STAFF REPORT

ITEM: Northport 2nd Addition Final Plat

To: Emily Becker, City of Lake Elmo Planning Director
From: Lucius Jonett, Wenck Landscape Architect
Date: June 21, 2018
Subject: City of Lake Elmo Landscape Plan Review
Northport 2nd Addition, Review #1

1 PHASE 2 SITE PLANTING
2 1"=50'-0"

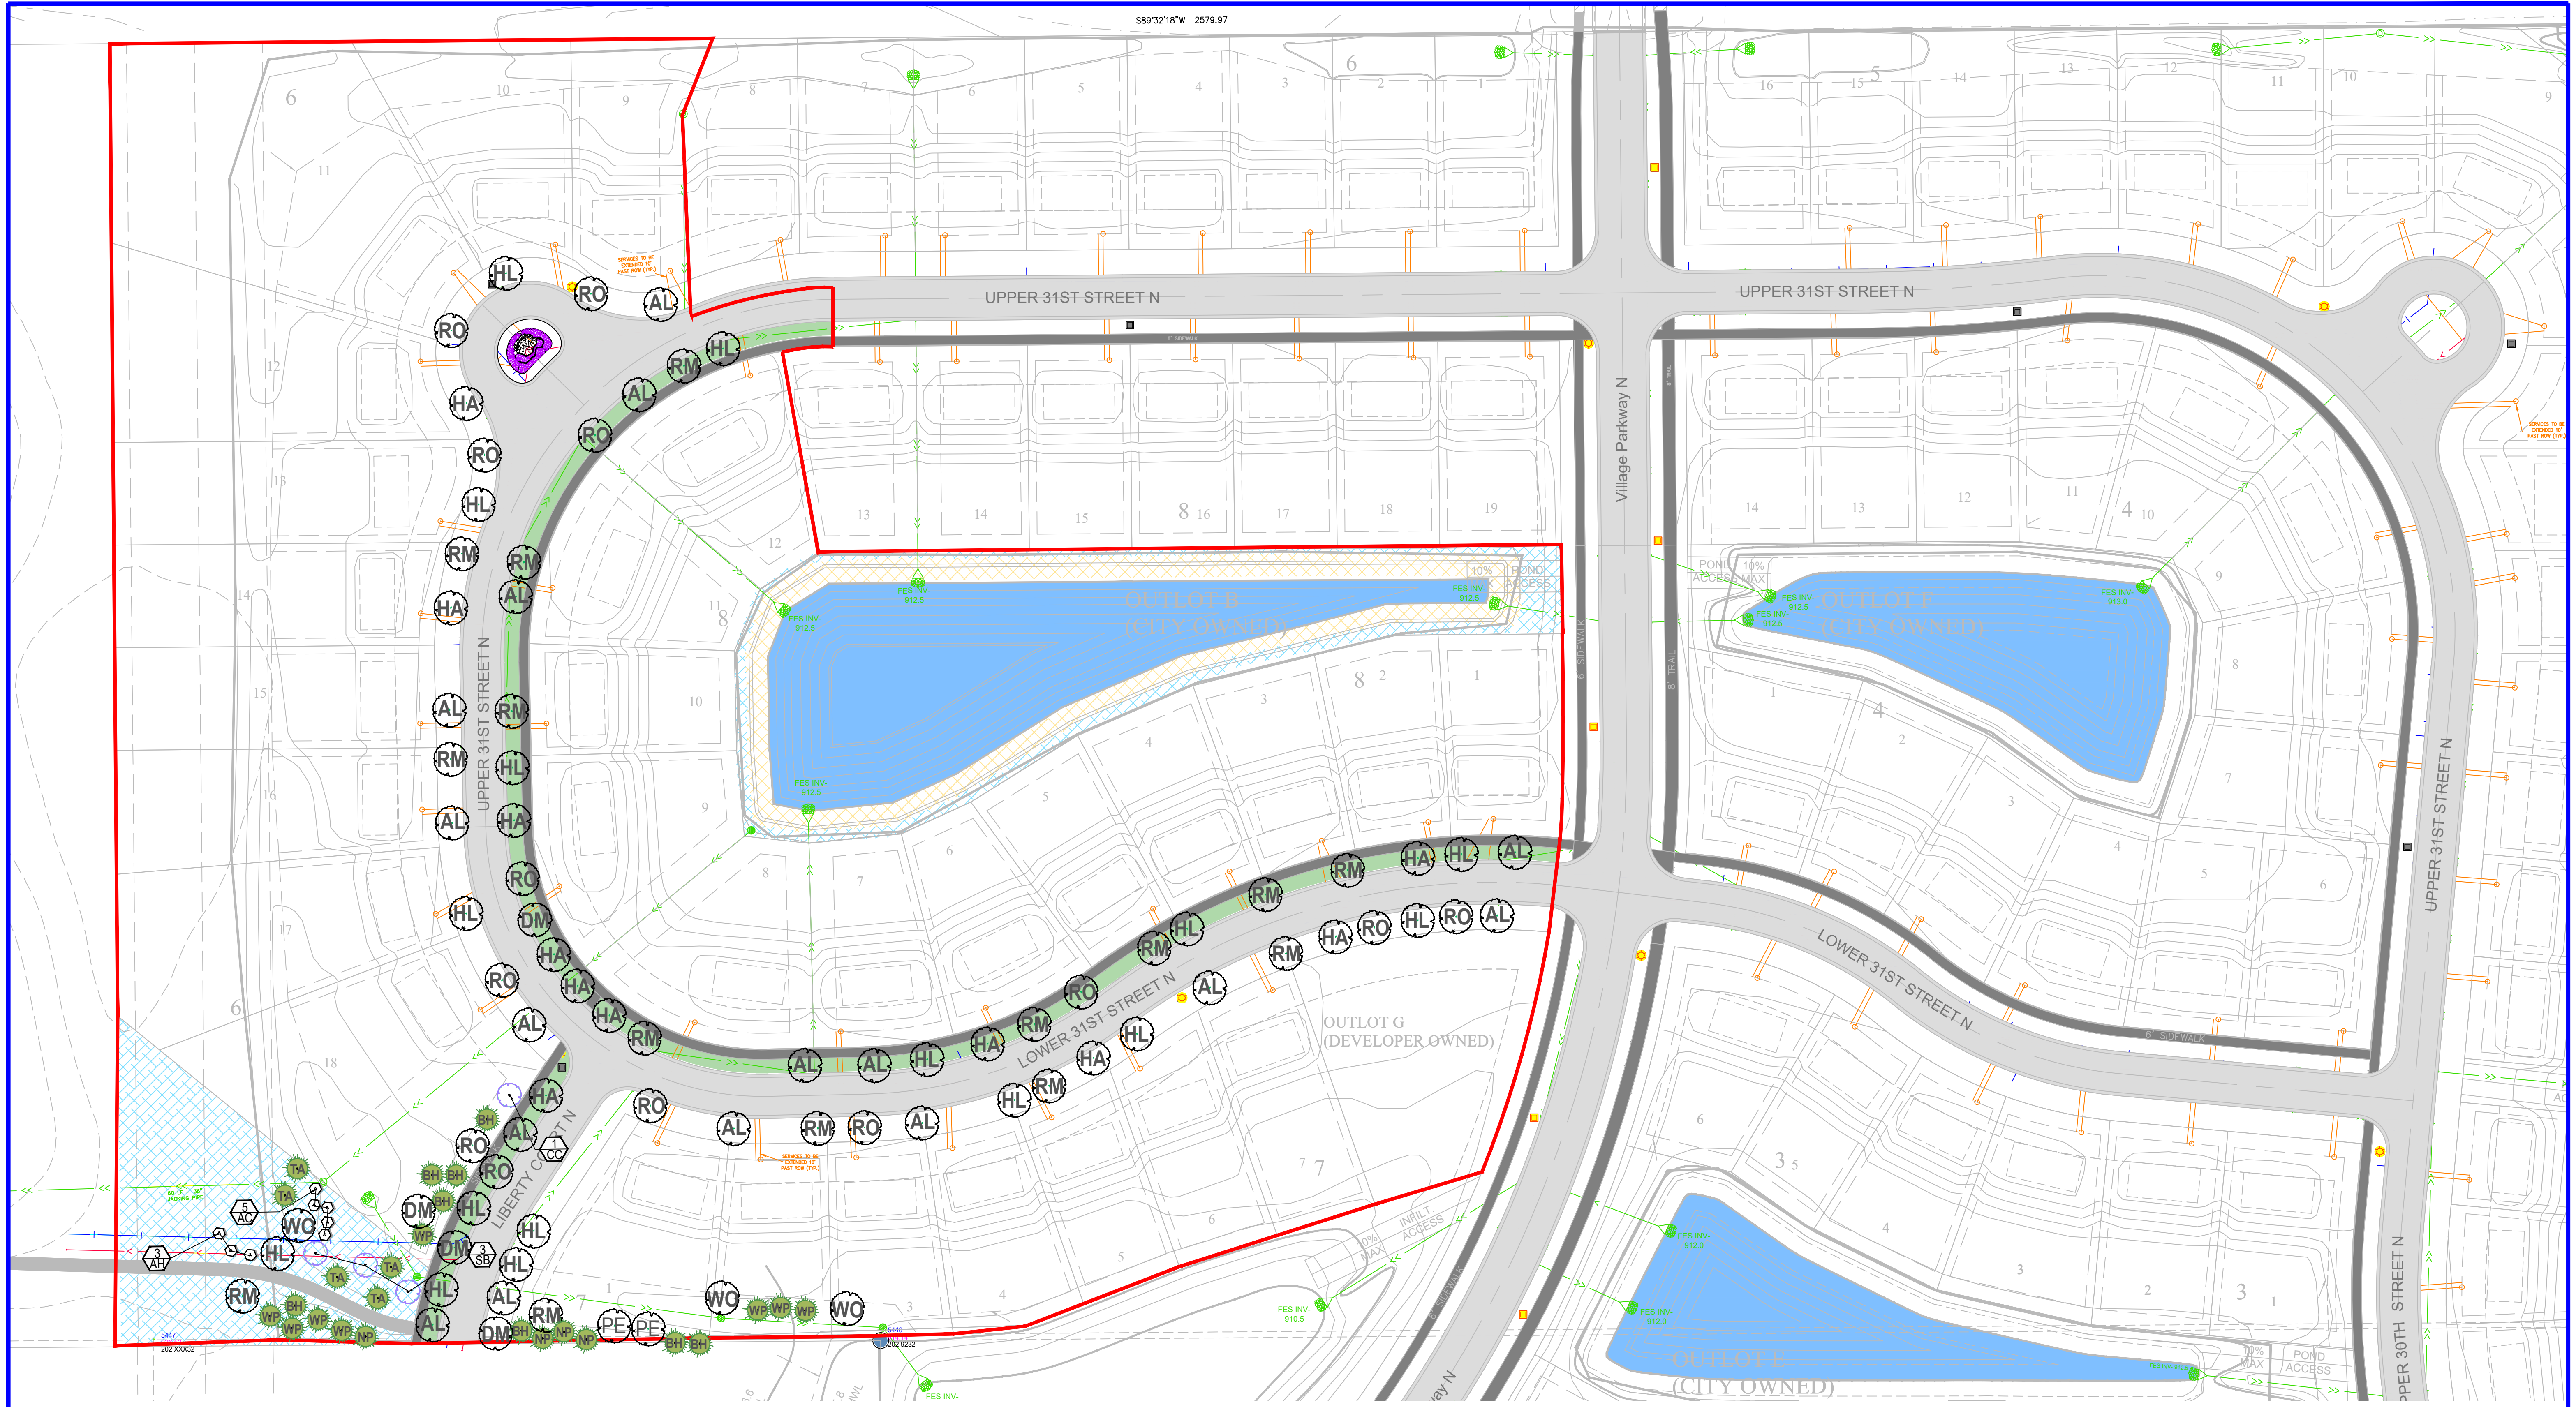
Landscape Plans. The City's Landscape Architect reviewed the landscape plans, and the report is attached. There are 11 tree discrepancies that need to be corrected, and the trees should be spaced further apart. Trees that do not fit the larger spacing can be moved to the buffer areas. Further, there are a number of utility conflicts that need to be corrected. It is a recommended condition of approval that the landscape plans be updated per these comments and resubmitted and approved by the City.

- 1. The following discrepancies between the plant schedules and what is shown on plan are:
 - a. Plant schedules should be labeled Phase 2
 - b. There is an 11 tree discrepancy that should be corrected:
 - i. The total of 67 trees does not match what is listed in the table
 - ii. Autumn blaze maple calls for 14 in the tables and 15 are shown on the plan
 - iii. Deborah Schwedler maple calls for 2 in the tables and 4 are shown on the plan
 - iv. White oak calls for 17 in the tables and 3 are shown on the plan
- 2. Trees are shown approximately 25' to 30' apart in areas of the plans (along Liberty Court North and some of the sections of Lower 31st Street North. Street trees should be spaced at least 35' apart to match the approved Phase 1 landscape plans (Upper 31st Street North) more closely. Trees that do not fit the larger spacing can be moved to buffer areas.

- 1. Submit a revised landscape plan addressing the findings listed above.

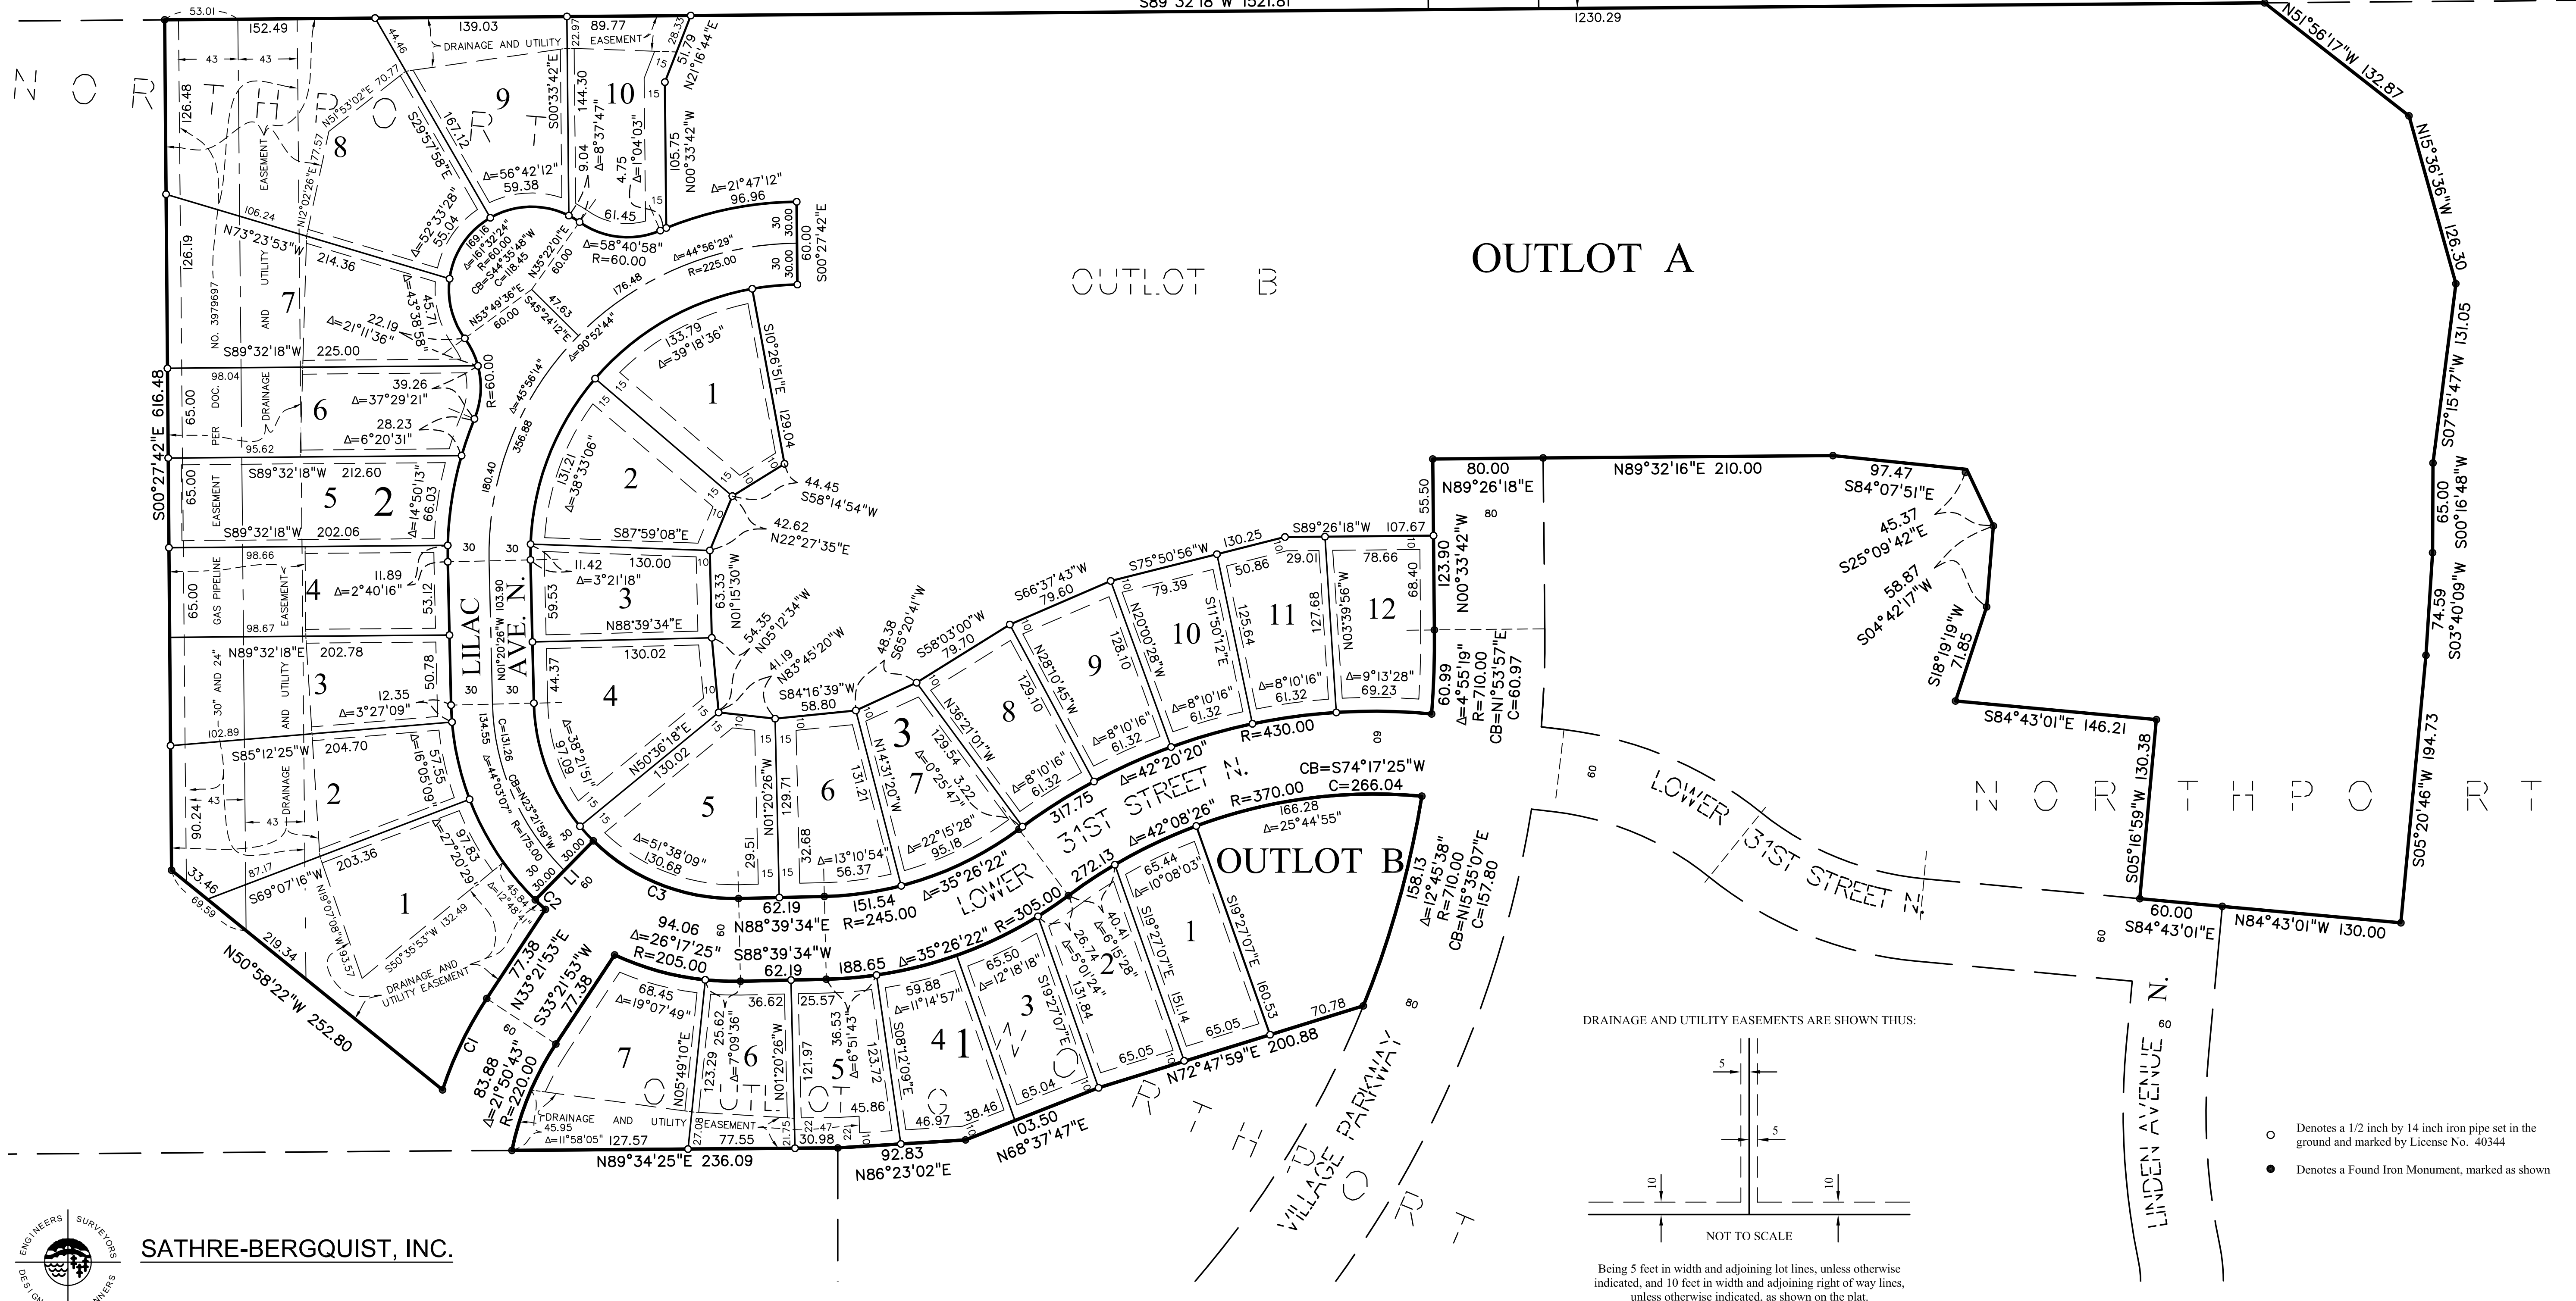
- 4) Final plat approval shall be contingent upon either removing Lot 10, Block 2 and Lot 1, Block 3, or adding a temporary cul-de-sac per City detail 807B at the street termination point for Upper 31st Street North.

- Final Plat approval should be contingent upon the Final Plat including a drainage and utility easement over all of Outlot A, 2nd Addition.
- Final Plat approval should be contingent upon the Final Plat either removing Lot 10, Block 2 and Lot 1, Block 3, or adding a temporary cul-de-sac per City detail 807B at the street termination point for Upper 31st Street.
